ADDENDUM NO. 1

May 25, 2022

Modify Atrium Lighting & Sprinklers – Mann Library
Addendum No. 1
May 25, 2022
Page 2

100% CONSTRUCTION DOCUMENTS
**SUCF 161039 - Modify Atrium
 Lighting & Sprinklers-Mann Library**
 237 Mann Drive, Ithaca, NY 14853

A151R1

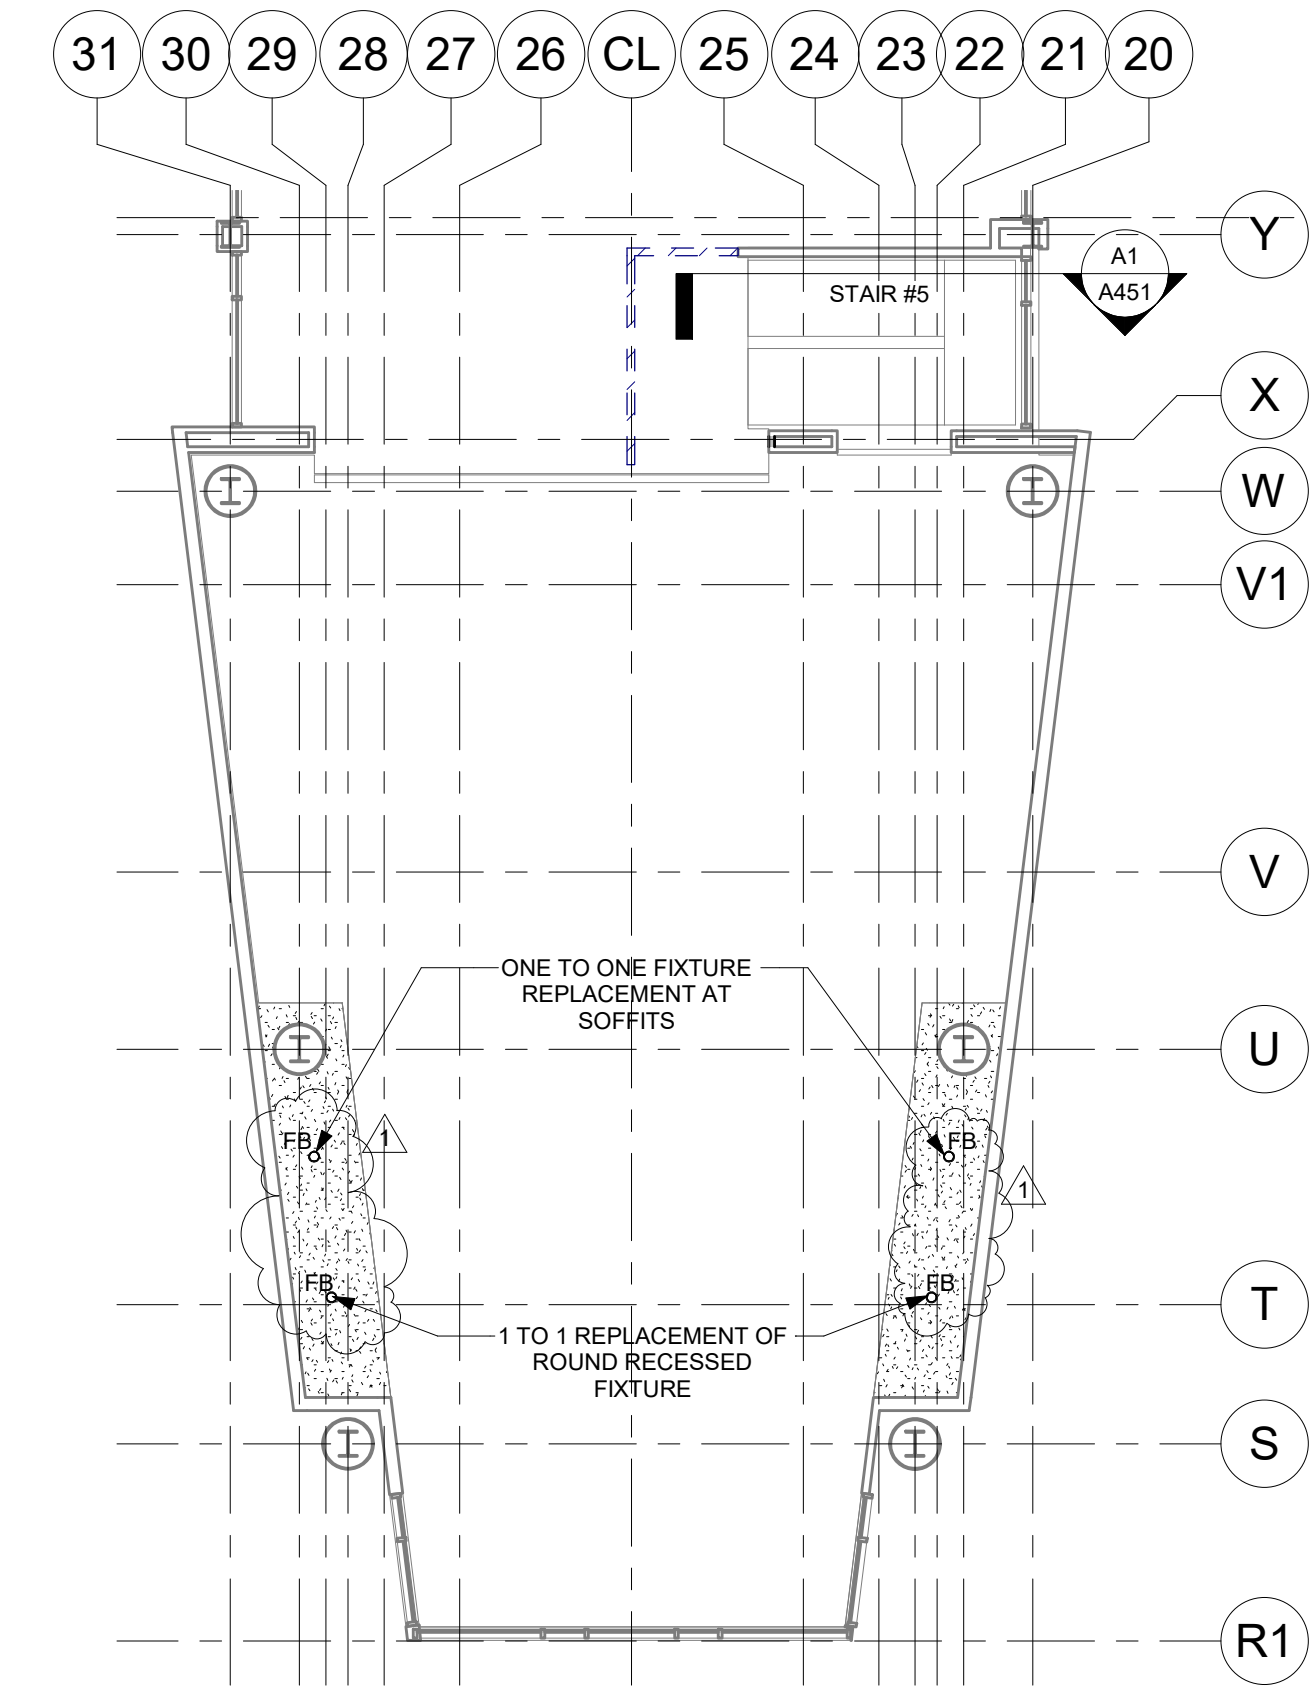
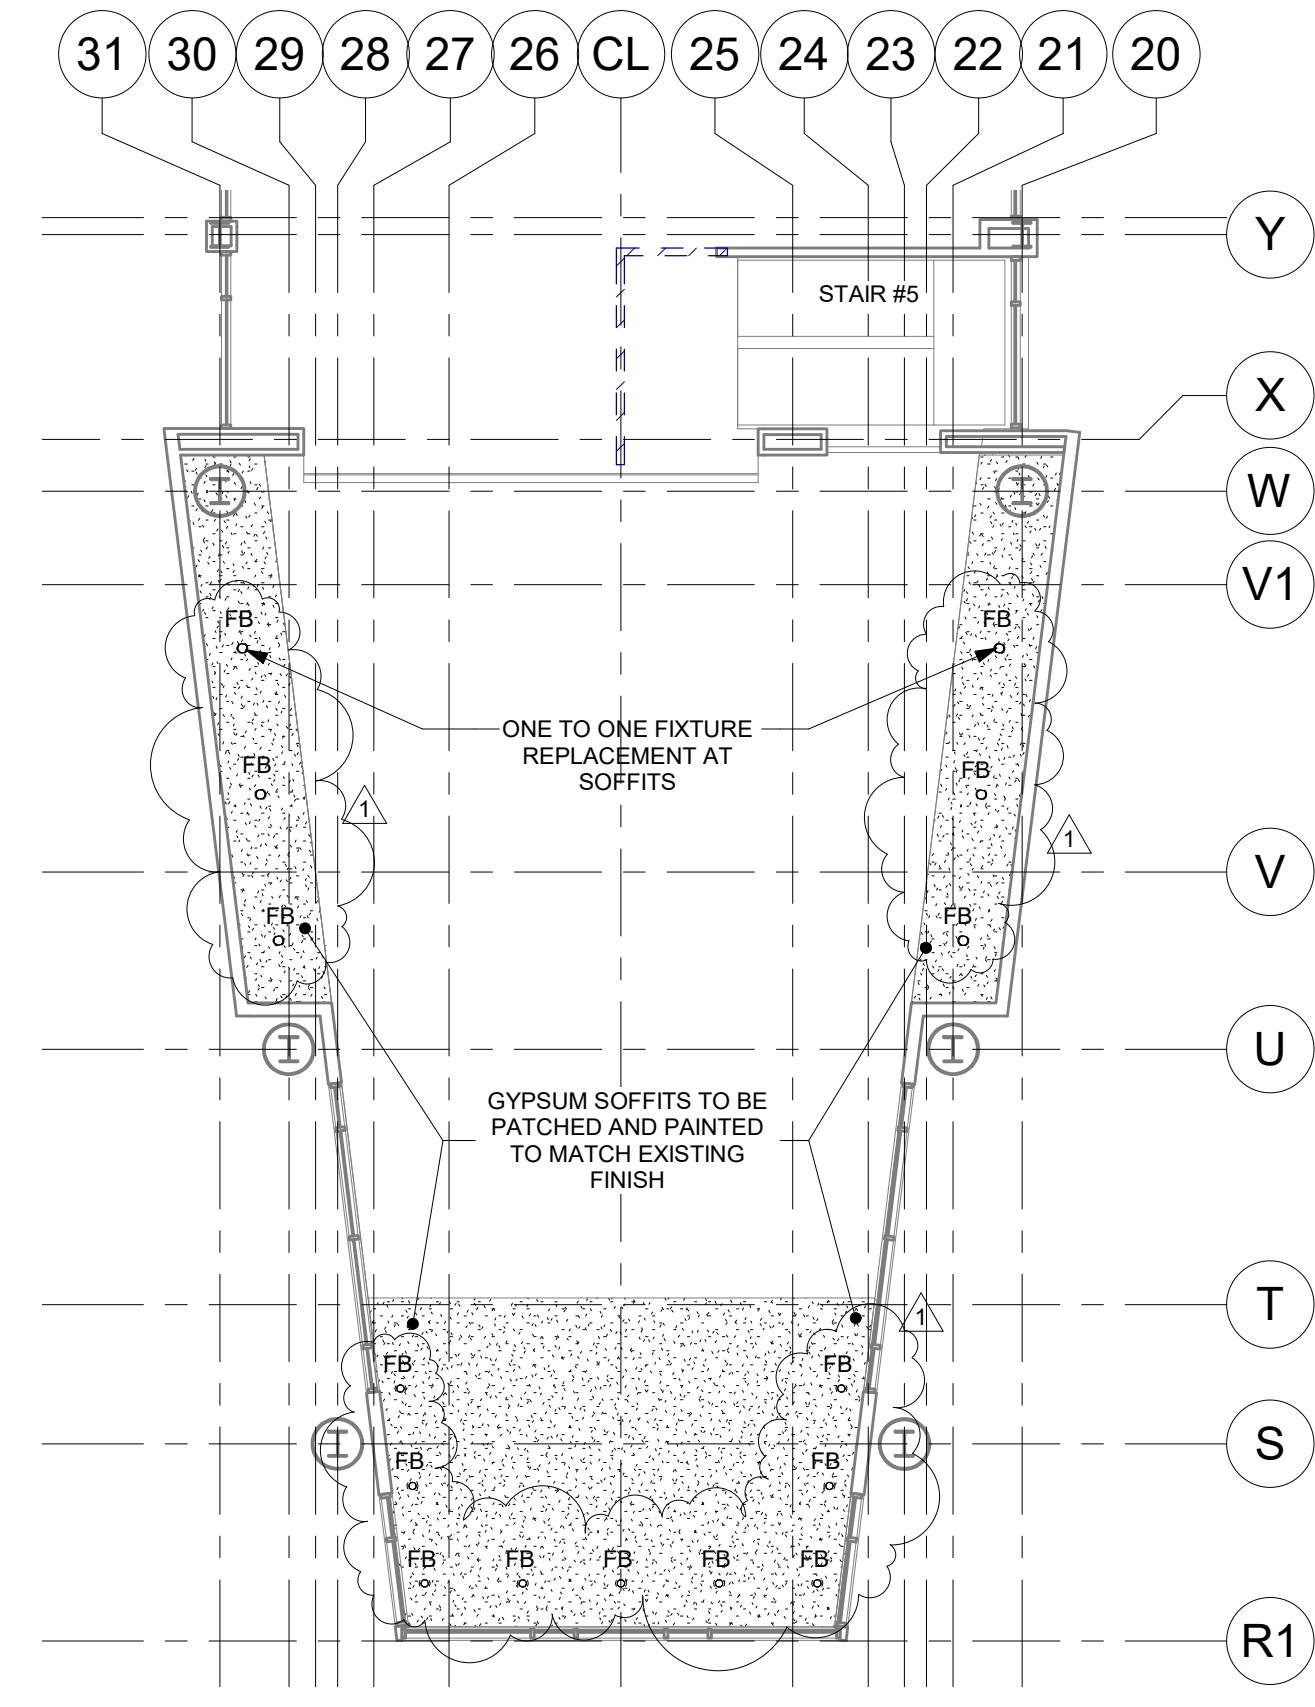
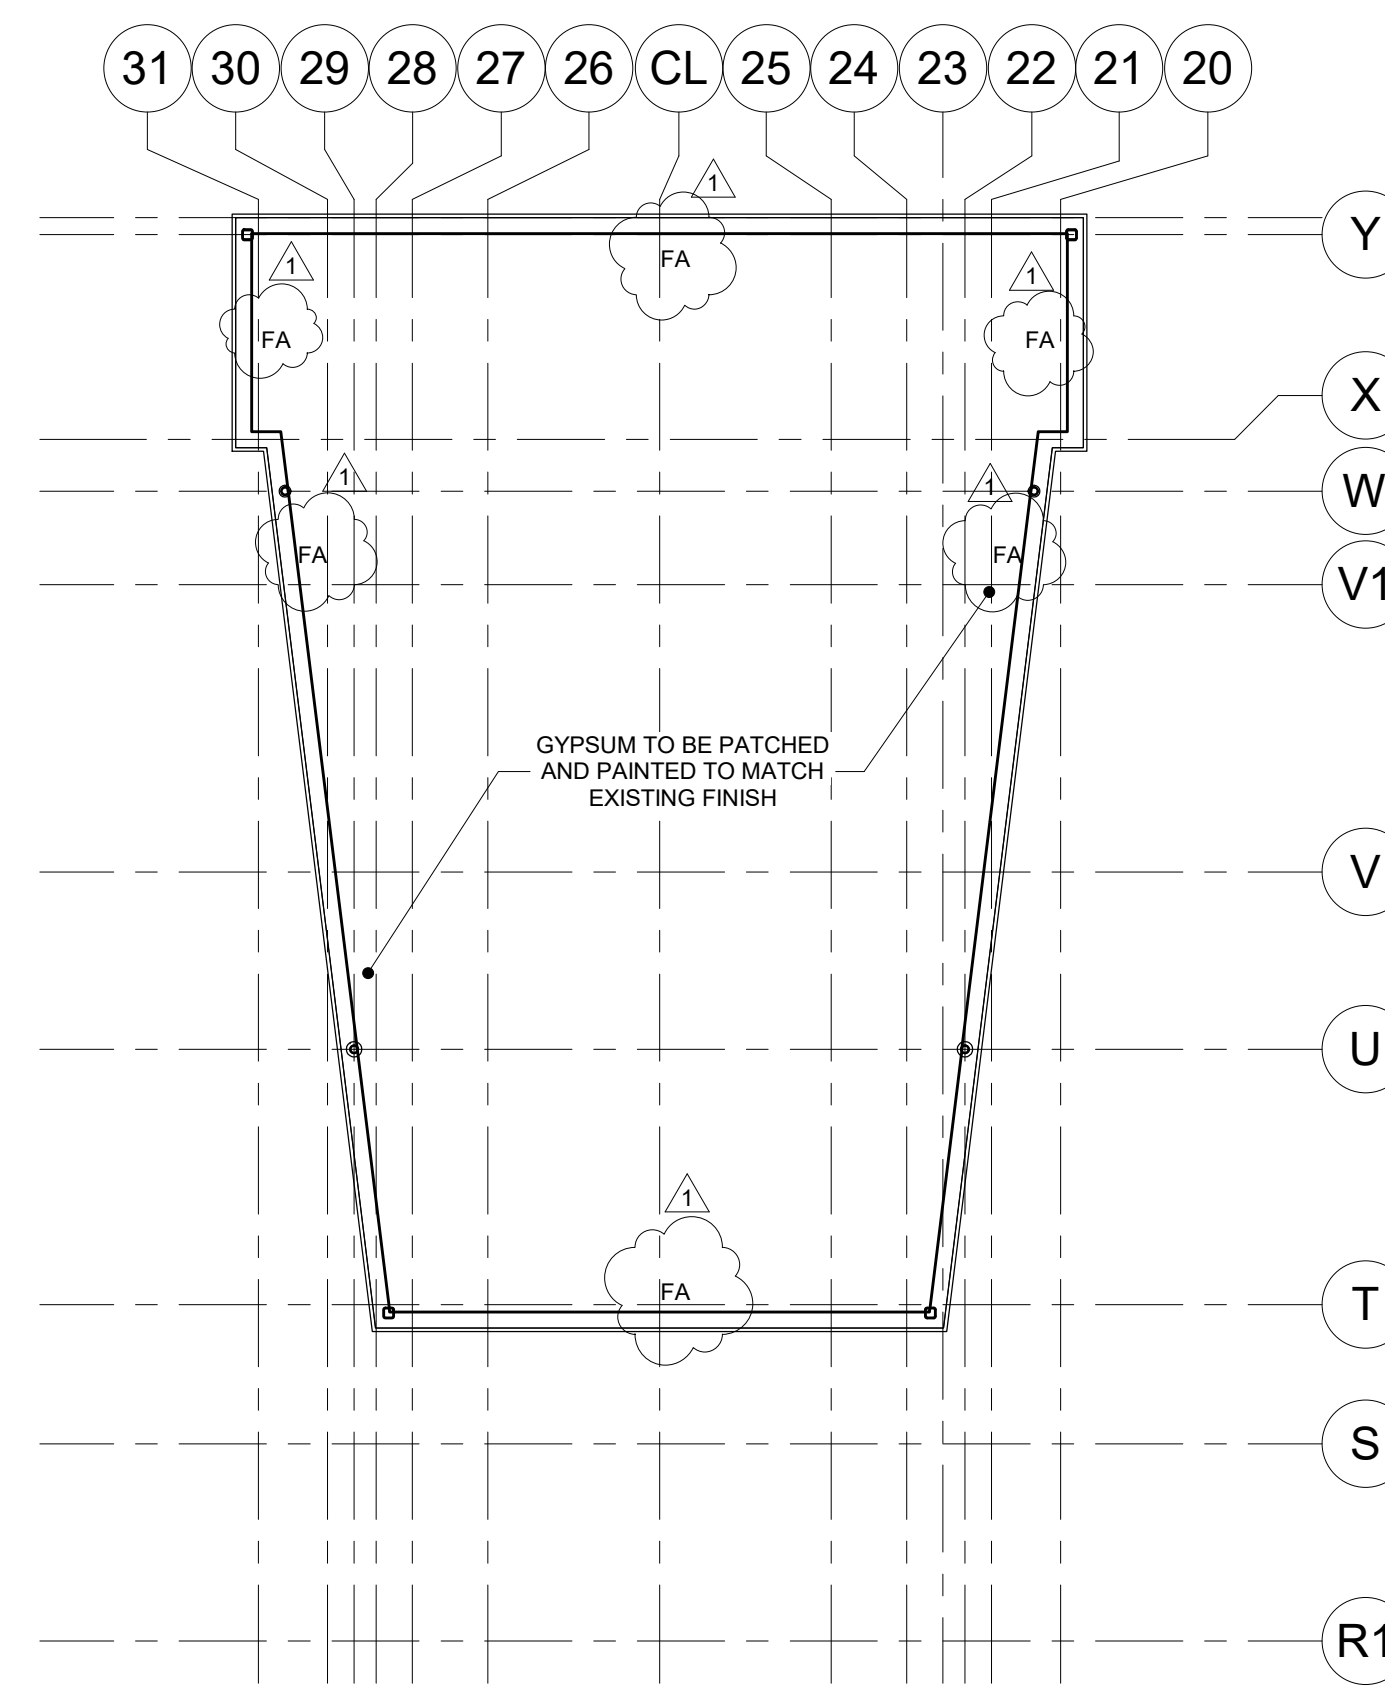
RFI/ Response Index	Page/ Dwg./Spec./Rep. Number	Section/ Paragraph/ Topic	RFI	Design Team Response
1			The specifications state this is to be hand delivered to facilities, and the attached SUCF descriptions say it's the EB bidding module. Can you please confirm and verify how these bids are to be turned in?	Documents are to be hand-delivered to 121 Humphreys Service Building per the documents as this is an State bid.
2	A151		Lighting schedule missing.	See Addendum No. 1, Item 3.
